**Board of Zoning Appeals Meeting  
November 21, 2023**

| <b>CASE NUMBER:</b>          | <b>V-23-0015</b>  |
| <b>VARIANCE REQUEST:</b>     | <b>Encroachment into the 75-foot stream buffer to construct a patio, fire-pit and retaining walls</b> |

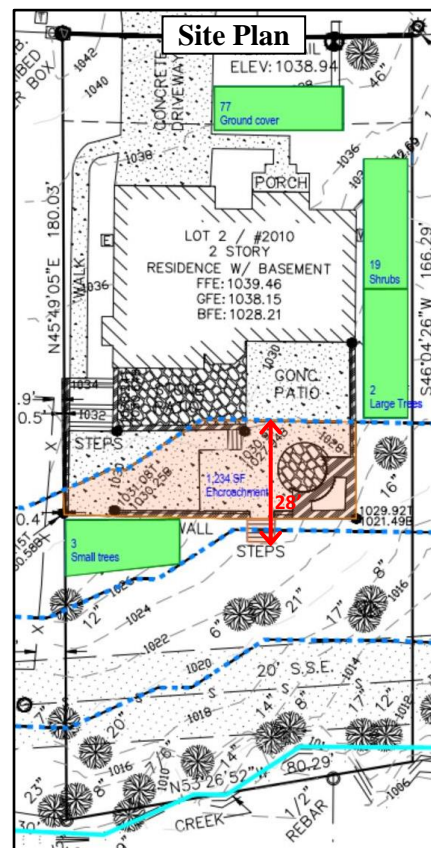
The Applicant is requesting to encroach 28 feet into the City’s 75-foot stream buffer to build a patio, fire-pit and retaining walls. The proposal will result in approximately 1,234 sq. ft. of total impervious surface (highlighted in orange) in the stream buffer. The Applicant has not proposed any new land disturbance within the State’s 25-foot stream buffer.

The Applicant has proposed to plant two red-maple (large) trees, three florida-maple (small) trees, 19 buckeye shrubs and 77 ground cover plants providing a total vegetative coverage of 1,312 sq. ft., to offset stormwater and environmental impacts associated with the requested encroachment into

- 1) The proposed development shall not exceed the following encroachments, as shown on the site plan received by the Community Development Department on October 9, 2023:
  - a. 28 linear feet of encroachment into the stream buffer;
  - b. 1,234 square feet of total impervious surface within the stream buffer.
- 2) A vegetative planting plan shall be submitted to the Community Development Department, as part of the building permit resubmittal. Said plan shall be consistent with the mitigation plan received by the Community Development Department on October 9, 2023. The final vegetative planting shall pass City inspection prior to the closeout of issuance of a Certificate of Completion for the proposed improvements.
